## **Preferred Riverwalk Alternative Components – August 17, 2017:**

**RIVERWALK PARK AND BOARDWALK  
DRAFT MATERIALS LIST  
August 17, 2017**

**Riverwalk Park & Boardwalk**

Yarmouth, MA

**OPTION 1**

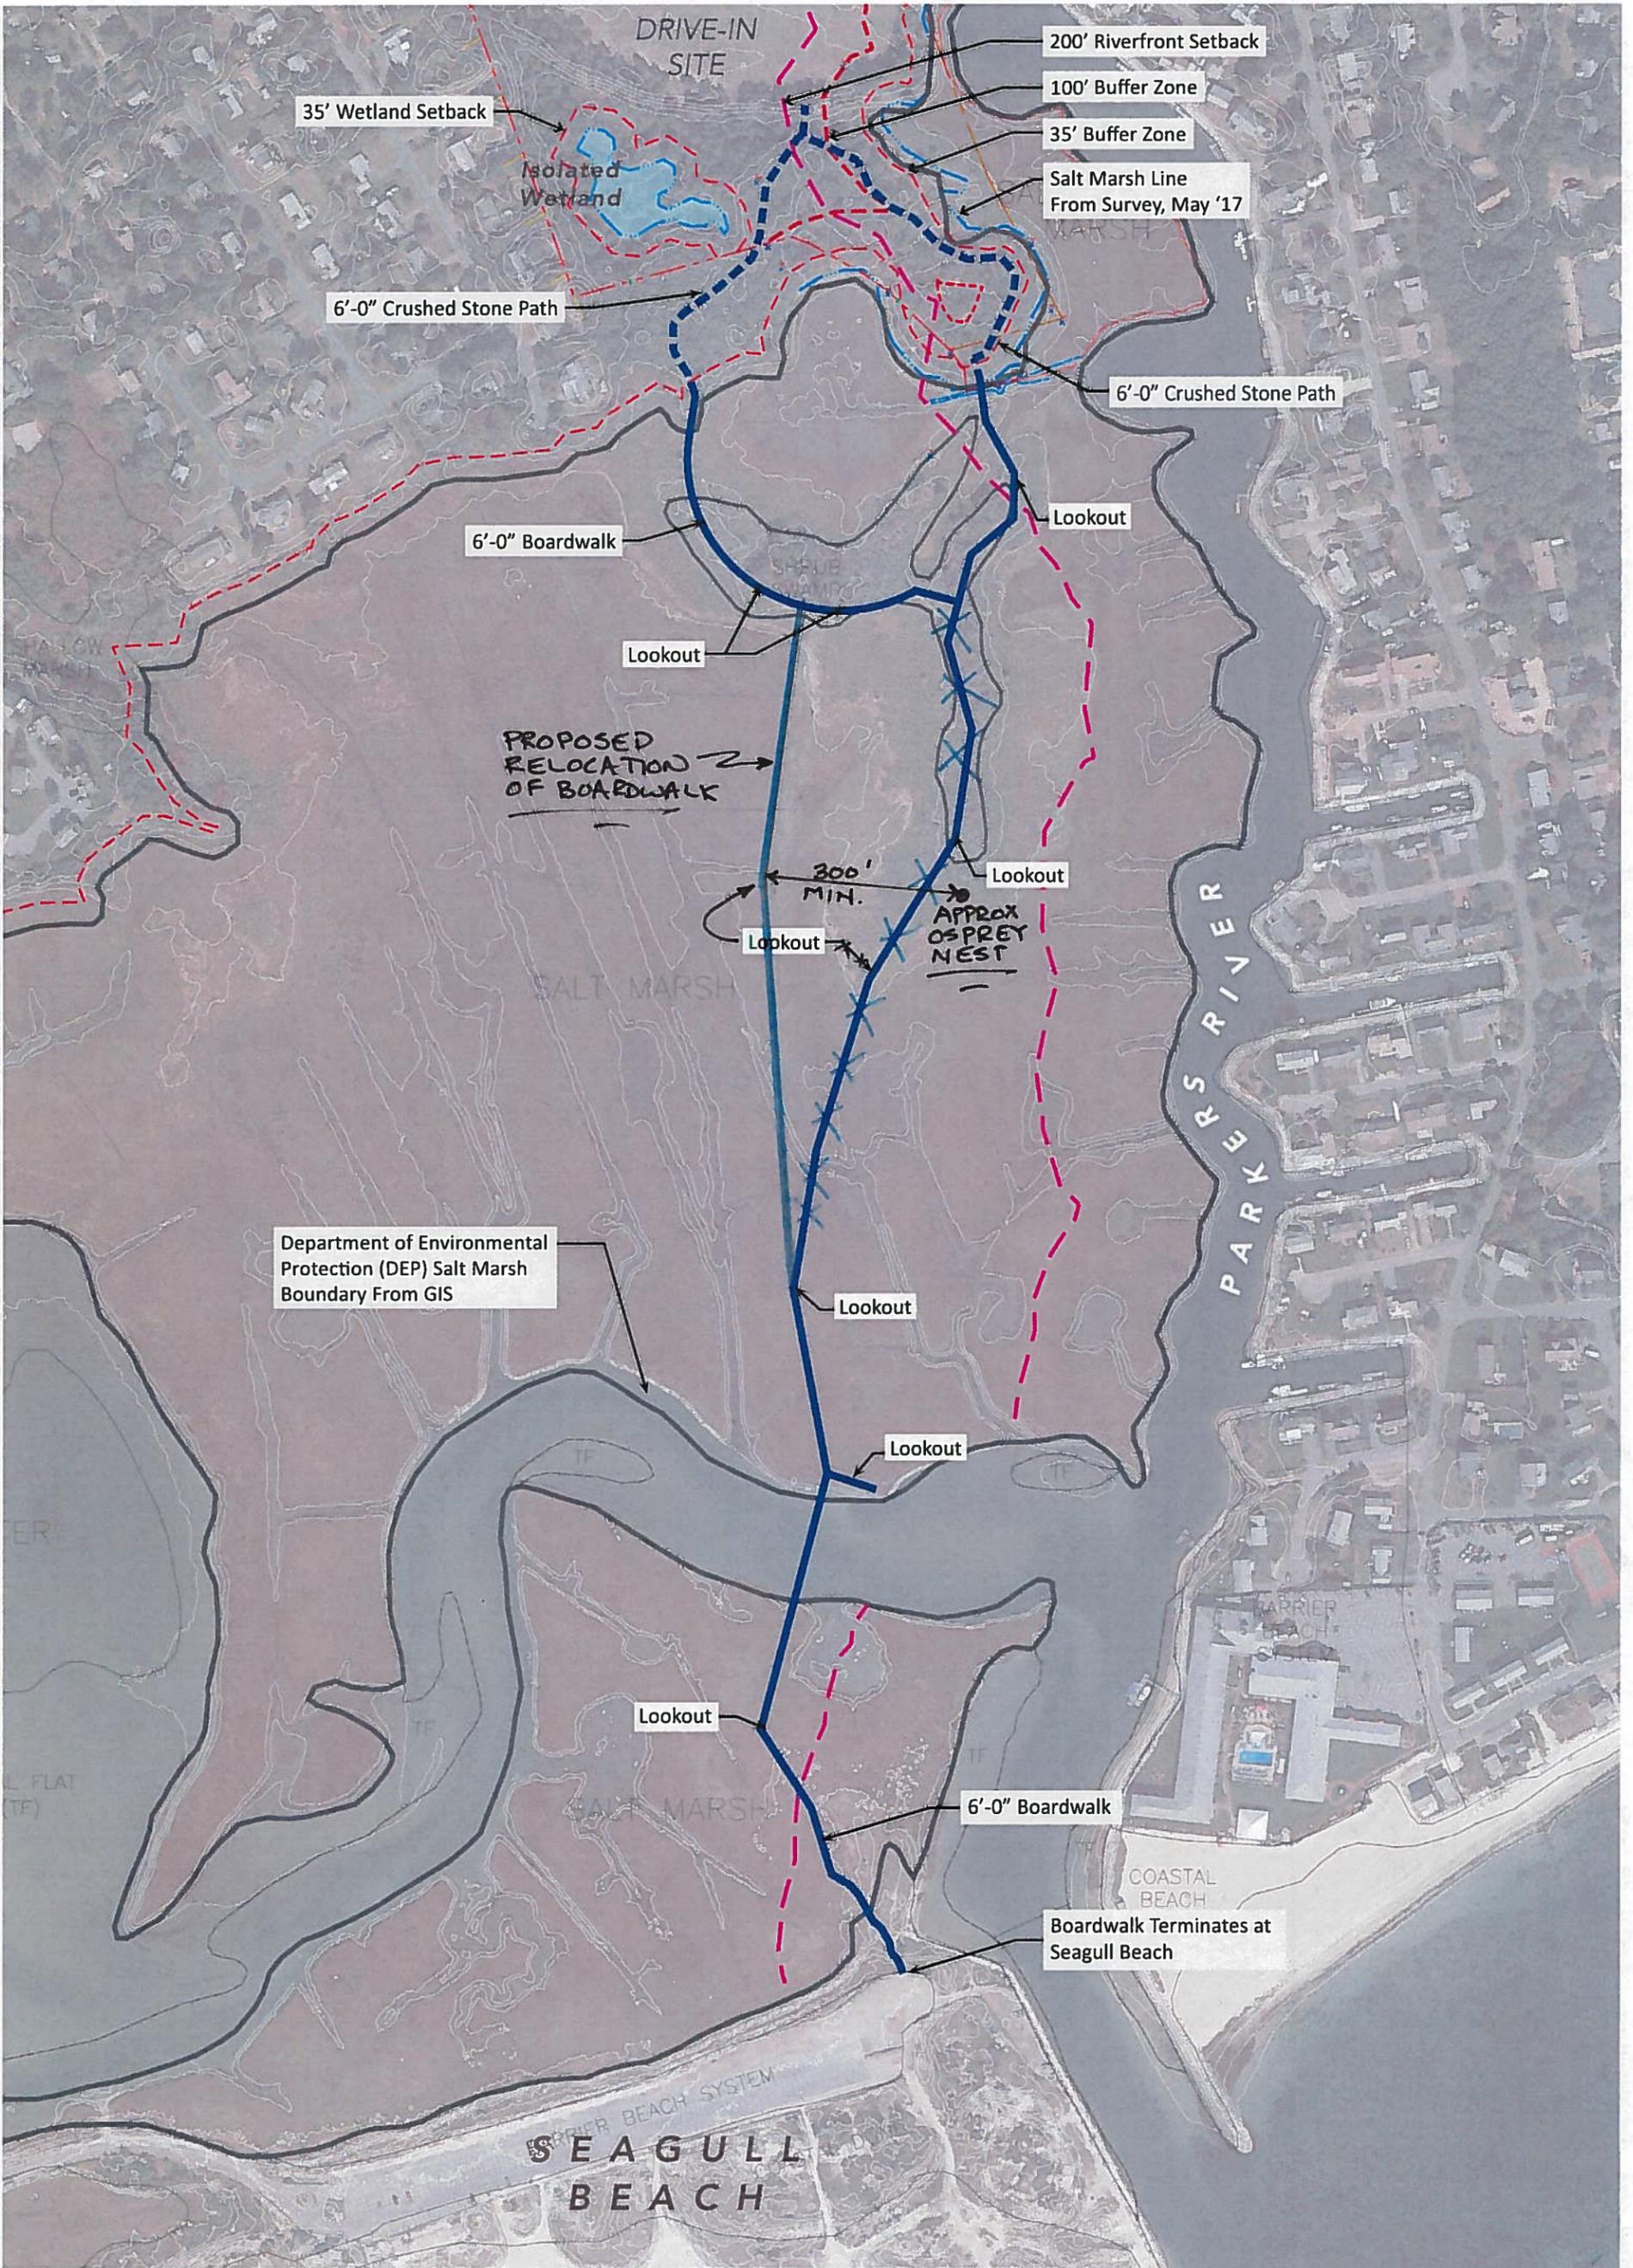
**Concept Sketch**  
 Riverwalk Park  
 Combination of Options A & C  
 6/28/17 - KDW  
 REVISED 8/15/17

Boardwalk Length: 1,500 LF  
 Crushed Stone Path Length: 1,250 LF

**PROPOSED REVISION 8/16/17**

**OPTION 2**

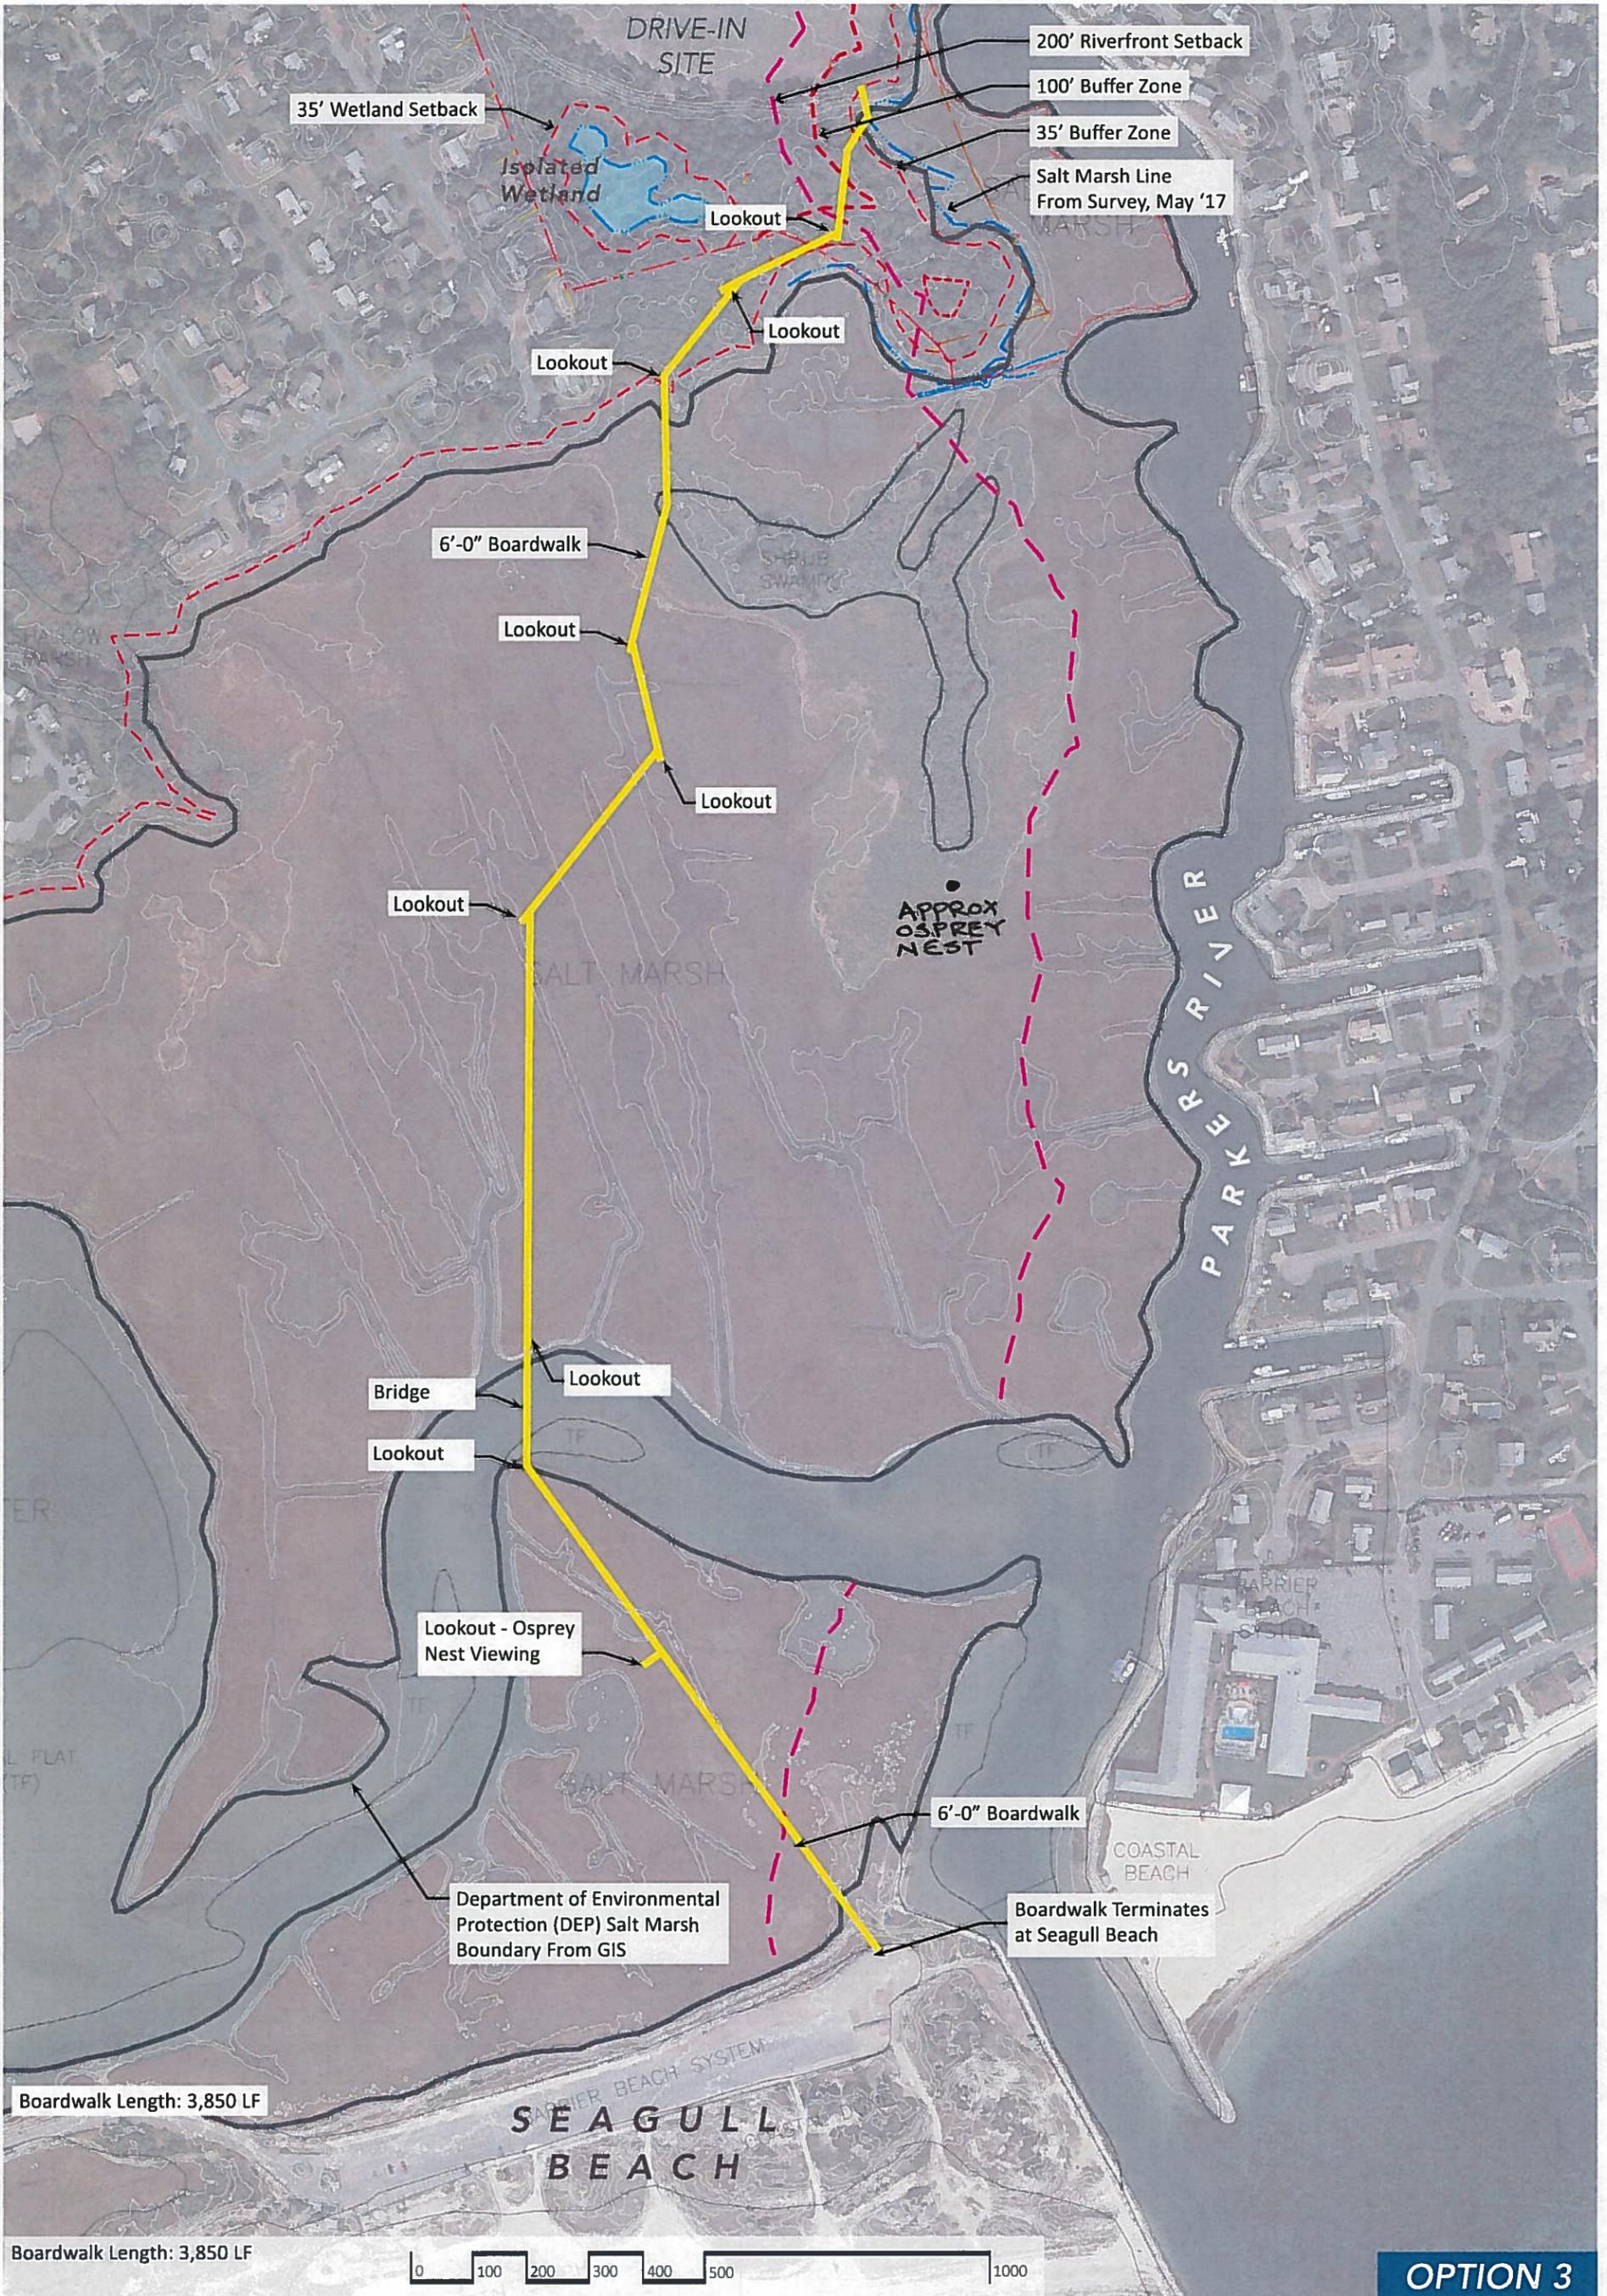
Boardwalk Length: 3,800 LF  
 Crushed Stone Path Length: 1,250 LF

**PROPOSED REVISION 8/16/17**
